Kraig Hill - Comment on BHPB LNG Deepwater Port DEIS/R - Draft 12-18-04

2004/G434

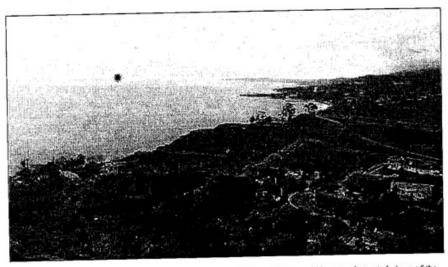
The DEIS/R also misstates how much of the FSRU would be visible from particular elevations on shore. I'm not certain how it does this (I simply have not had time to figure out where it goes wrong), but I can say this much: The DEIS/R's discussion of the curvature of the earth would have it that from my home's elevation of 230 ft. I should not be able to see *any* of Santa Barbara Island, yet I can see virtually all of it from here, 45 miles away. The implication is that the DEIS/R significantly understates the number of homes in Malibu and elsewhere that would have substantial views of the FSRU.

For my comments on the Scoping Draft I calculated that the majority of hillside homes in Malibu would have views of the FSRU. Consider that any homebuilder with a hillside lot in Malibu would do his or her best to site a house such that it has views of the ocean, and the sunset in particular. (See FIGURE 9.) For all these homes, the FSRU would situated more or less "center-stage" – especially at sunset, when it would first appear as a silhouette partially "eclipsing" the Winter sun, then at twilight it would appear as an industrial glow against the deepening colors of the sky.

The presence of marine haze at the horizon would obscure the view for about two-thirds of the year, and under clear conditions, the FSRU would appear as a very small object at the horizon. See the discussion under Impact AES-2, "Alter Nightime Ocean Views".

Section 4.4.3 has been revised and includes additional information. Appendix F provides information on visibility calculations.
